**DOCKET NUMBER 50-483
CALLAWAY PLANT
UNION ELECTRIC COMPANY
RESPONSE TO REQUEST FOR ADDITIONAL INFORMATION
ON REVISION TO TECHNICAL SPECIFICATION 5.5.9
"STEAM GENERATOR (SG) TUBE SURVEILLANCE PROGRAM"**

**REQUEST FOR ADDITIONAL INFORMATION
REVIEW OF THE CALLAWAY PLANT APPLICATION
FOR REVISION TO TECHNICAL SPECIFICATION 3/4.4
TAC NUMBER: MB1214**

Figure R6-22. Crack A22: Half Skip Reflection

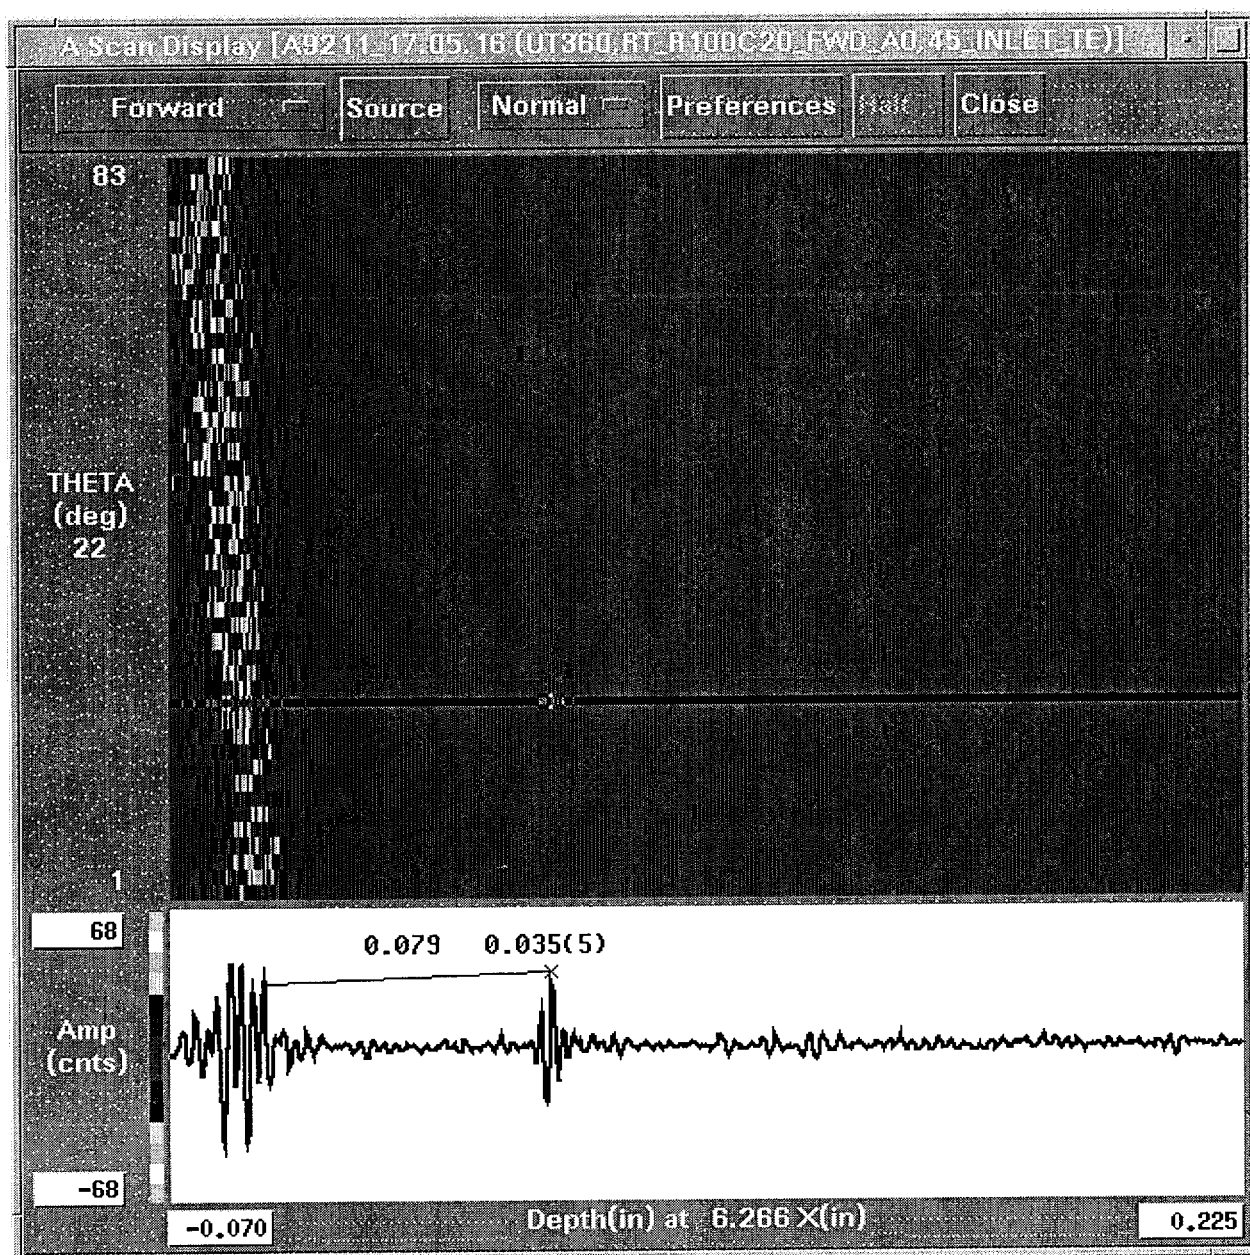
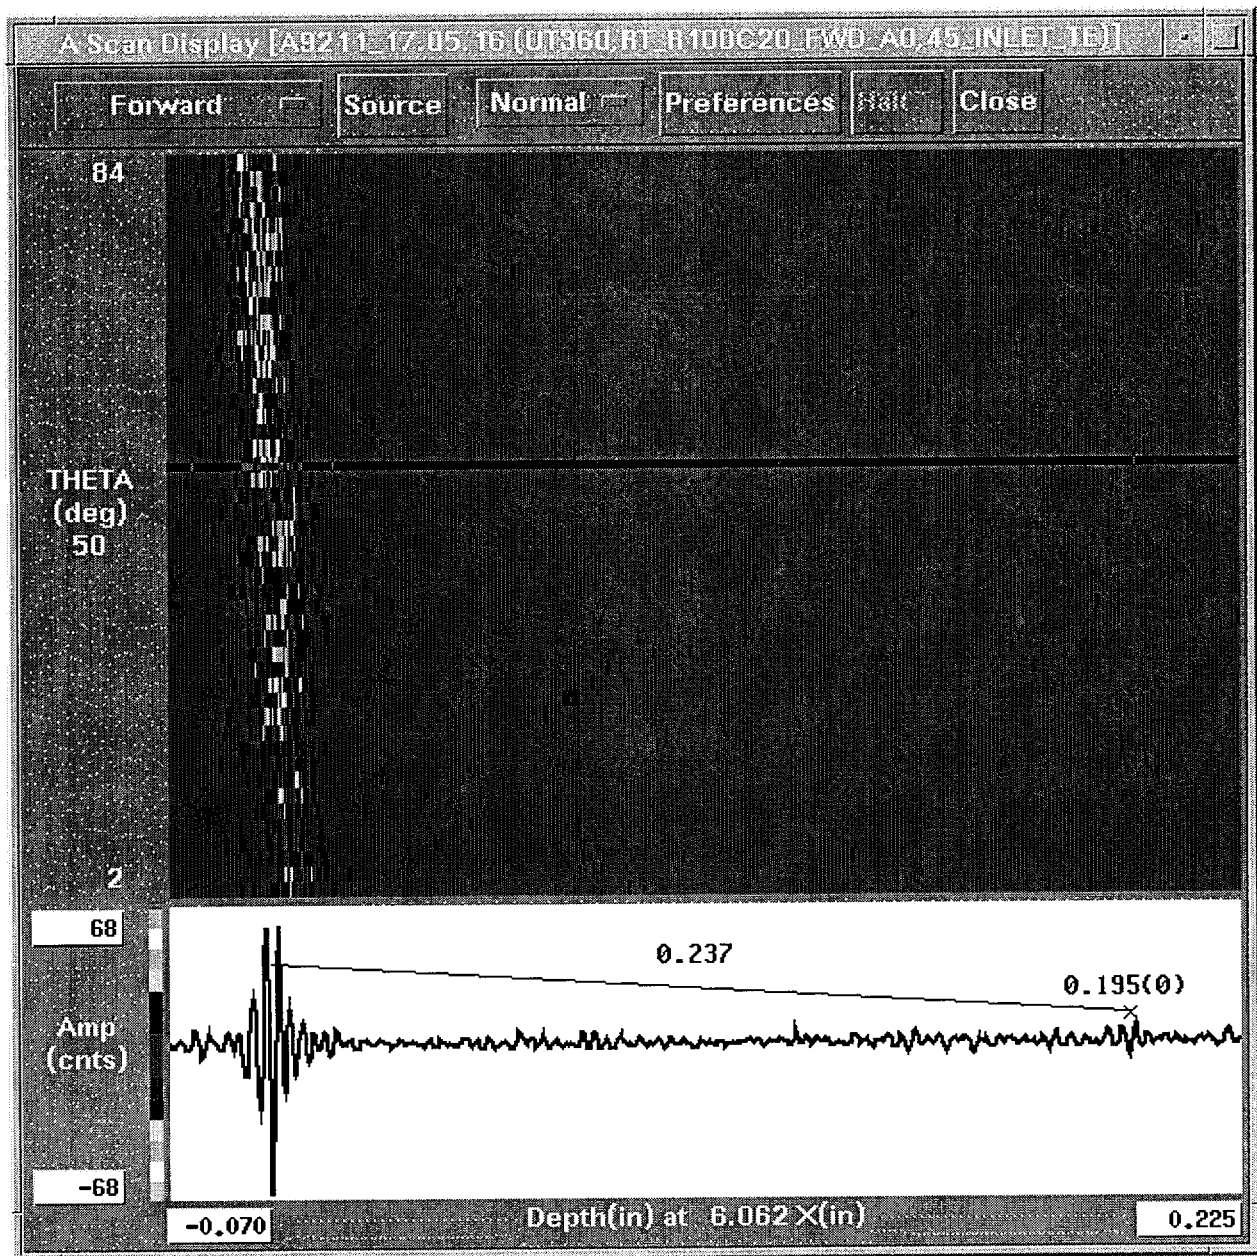
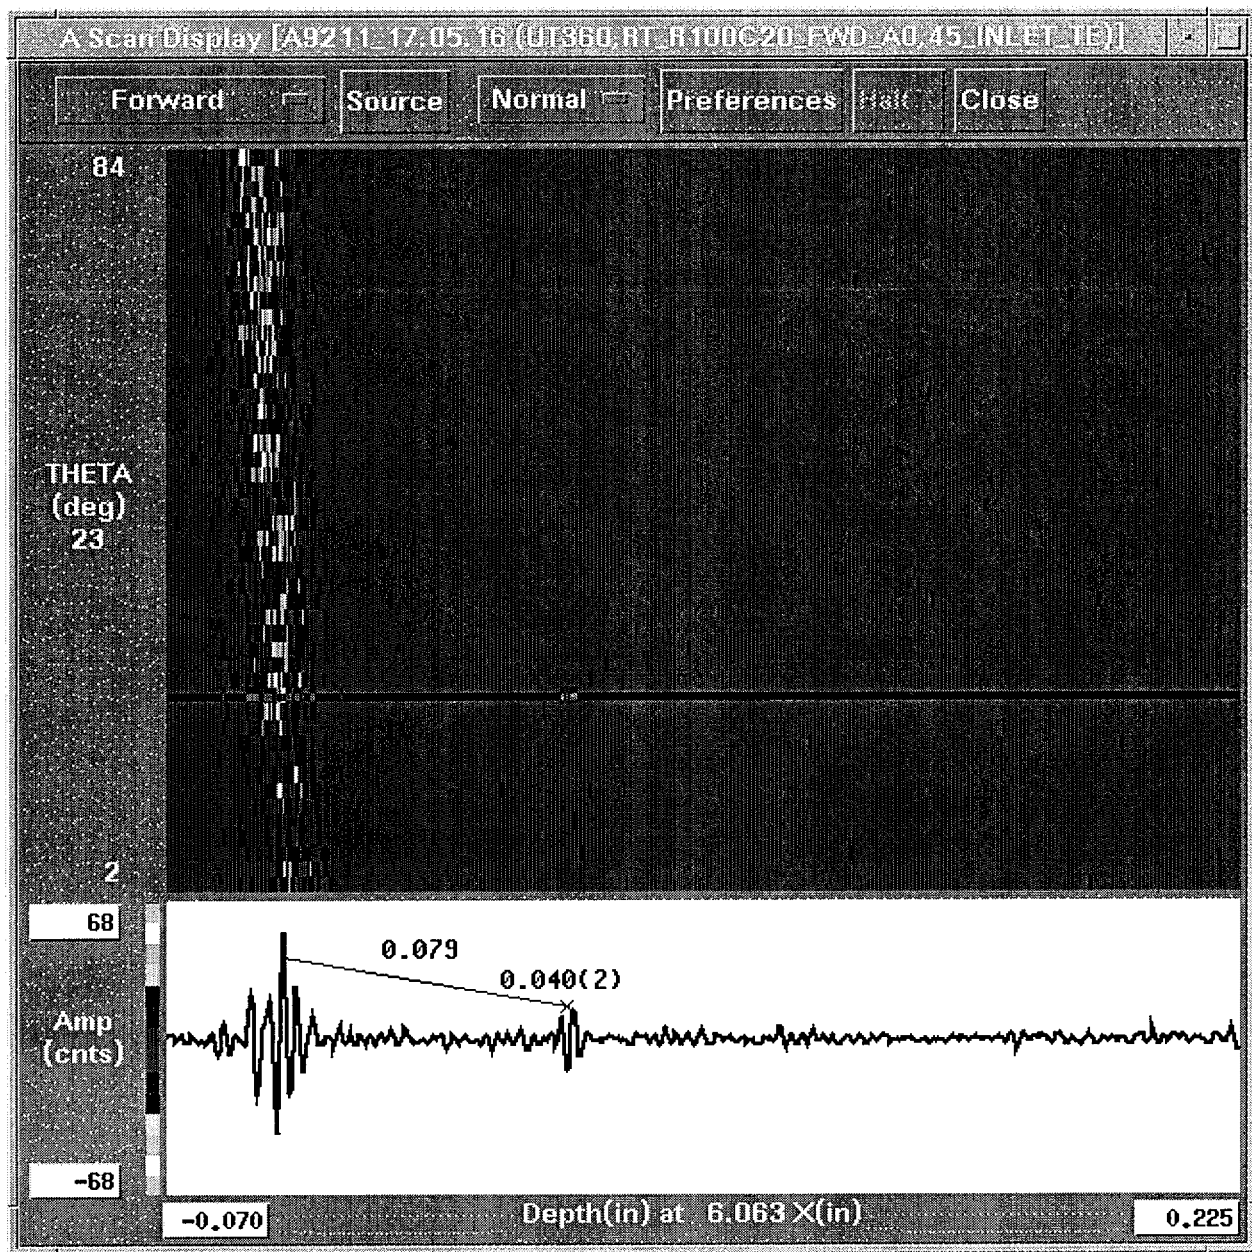
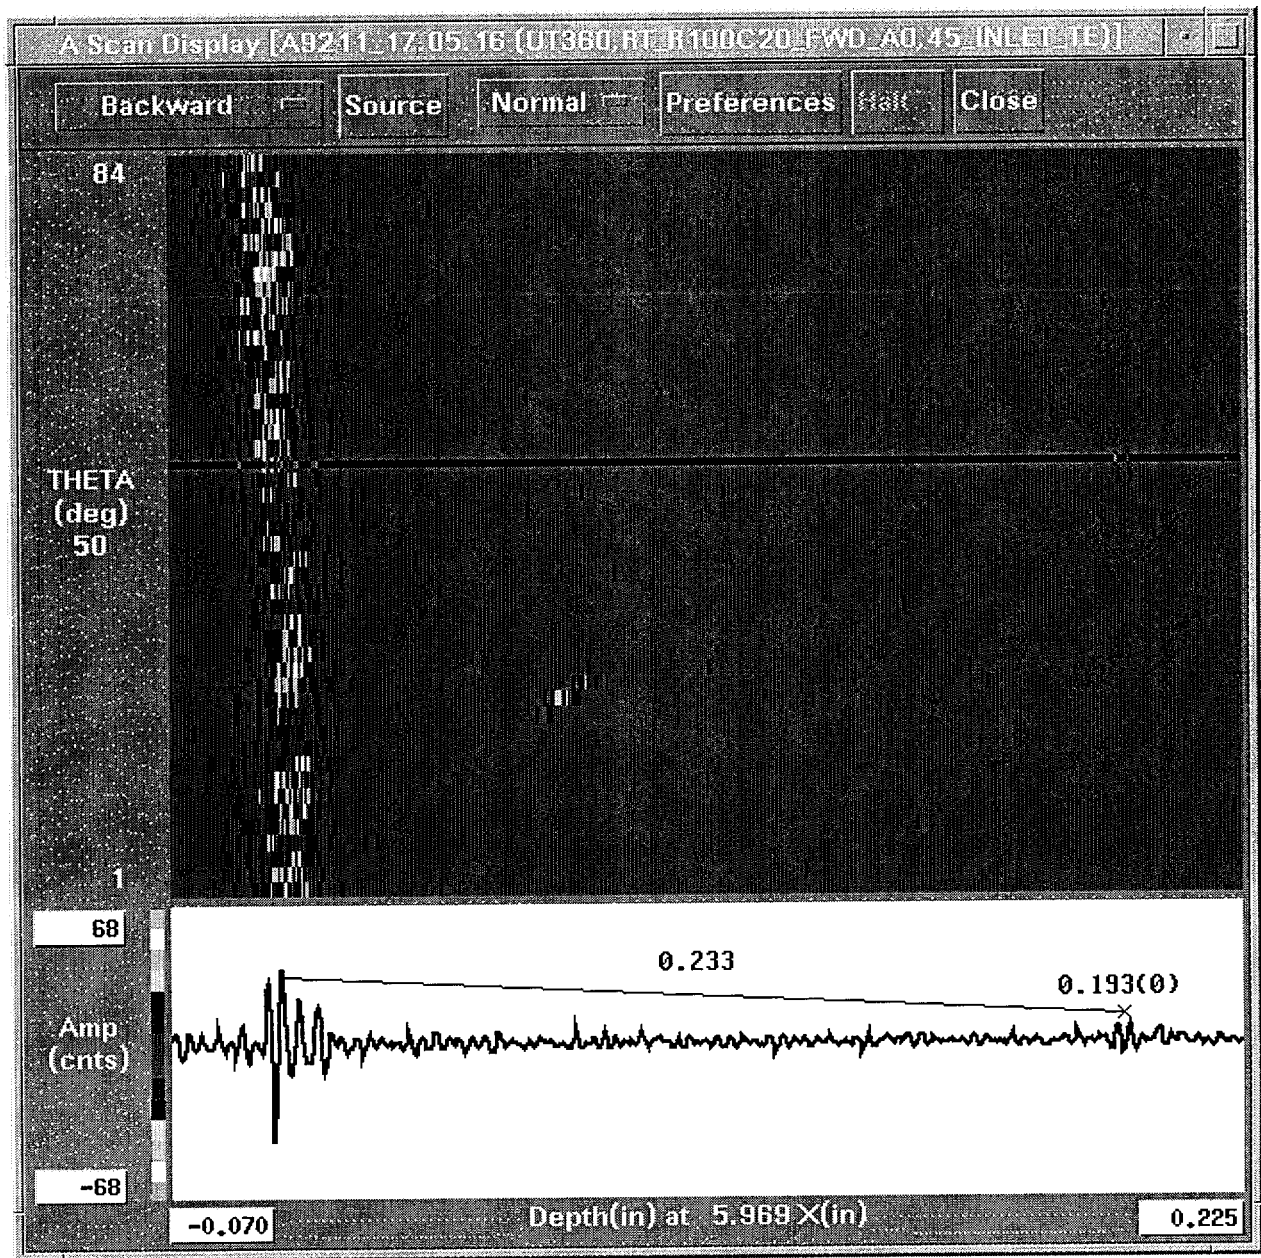
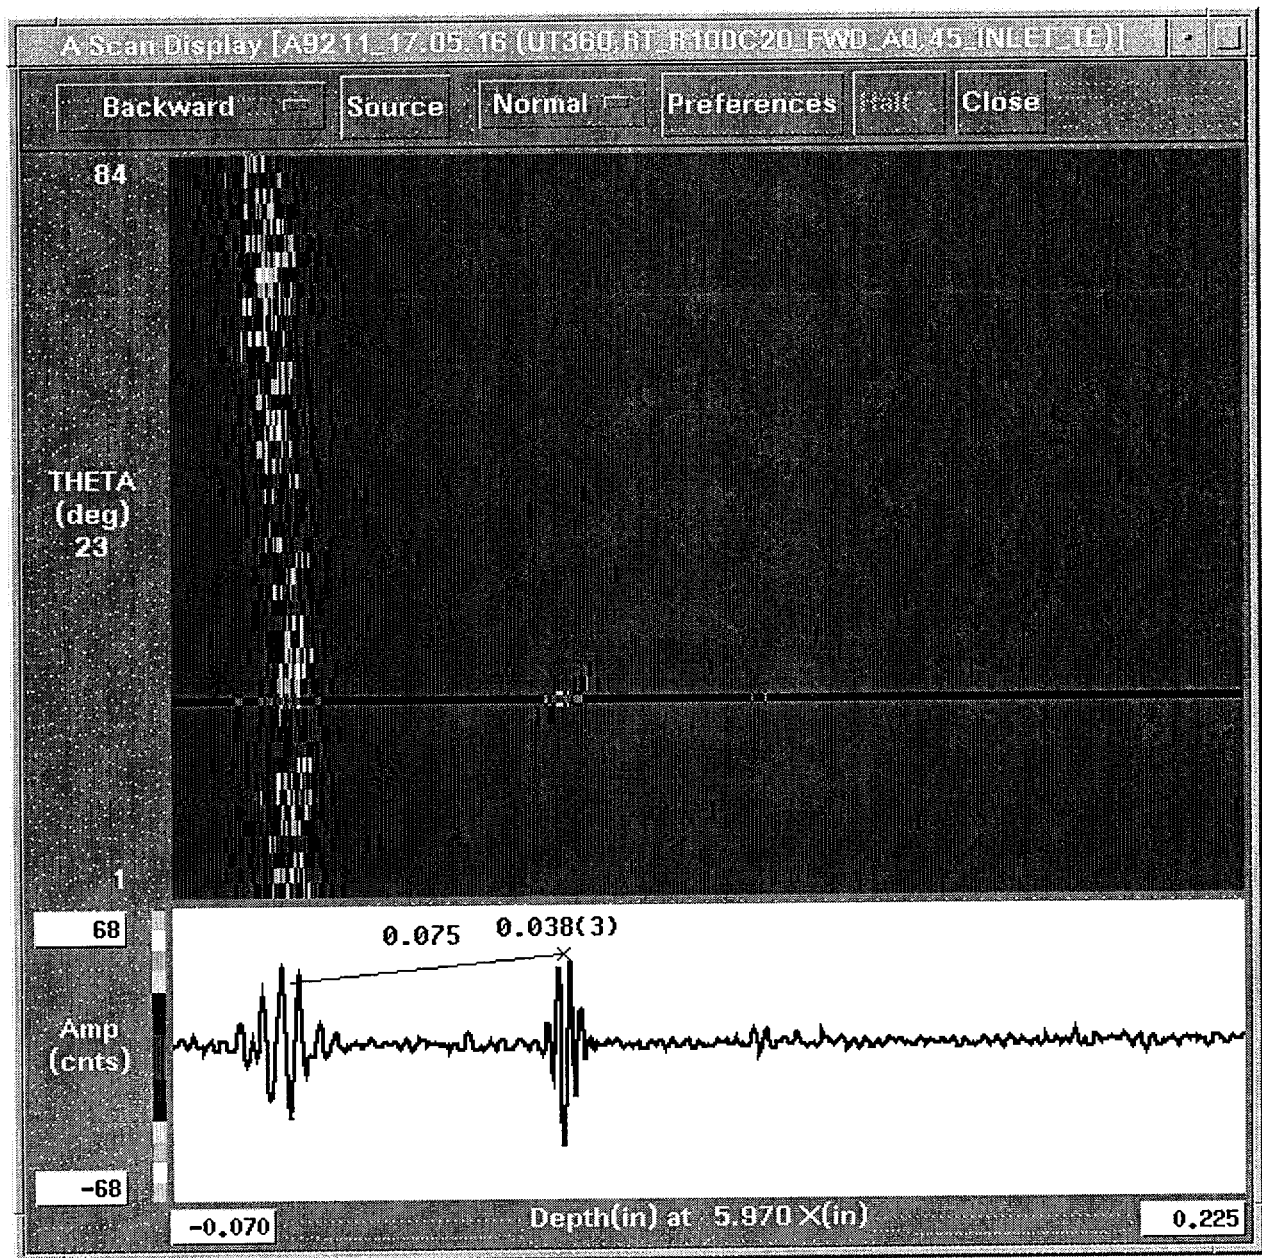
RAI # 6. During the meeting, FTI indicated that PWSCC detectability in the sleeve could be inferred from the ID notches in the UT calibration standards and the data sets containing pits. It is not clear to the staff how detecting EDM notches in the calibration standards or another degradation morphology such as pits would infer an ability to detect tight flaws such as PWSCC. Explain the basis for the statement that sleeve PWSCC ID defects will be detected, and the resulting sensitivity and POD, since the peer review (ETSS # 98404) only covers volumetric defects. Please provide additional discussion or, preferably, additional data to support the claims of the capability of the technique to detect PWSCC in the sleeve. (Question from the 6/7/01 meeting held with UE, FTI, and the NRC staff)

For crack A12, the UT measured combined wall thickness is 0.073 inch at the 6.3 and 6.4 inch axial locations. For crack A22, the UT measured combined wall thickness is 0.077 inch at the 5.9 and 6.1 inch axial locations and 0.080 inch at the 6.25 inch axial location. Both cracks are in the expansion transitions of their respective tubes. The expansion transition geometry did not adversely affect the detection of these cracks.

This is the one and one half skip reflection for crack A12 at the 6.374 inch axial location. The 0.185 inch depth (time of flight) and the 81 degree circumferential location will be used to qualify this reflection with the half skip reflection. The reflection depth from the surface, 0.225 inch, is nearly equal to the expected depth (three times the combined wall thickness) or $(0.073 * 3) = 0.219$ inch.

This is the half skip reflection for crack A12 at the 6.329 inch axial location. The delta depth is $(0.184 - 0.036) = 0.148$ inch. The delta displacement is $((81 - 56) * 0.006) = 0.150$ inch. Since these two results, (0.148 and 0.150), are within one pitch (0.015 inch), the half skip and the one and one-half skip have been correctly identified. The delta depth and delta displacement are also nearly equal to the expected value of two times the wall thickness.

This is the one and one half skip reflection for crack A22 at the 6.264 inch axial location. The 0.187 inch depth (time of flight) and the 49 degree circumferential location will be used to qualify this reflection with the half skip reflection.
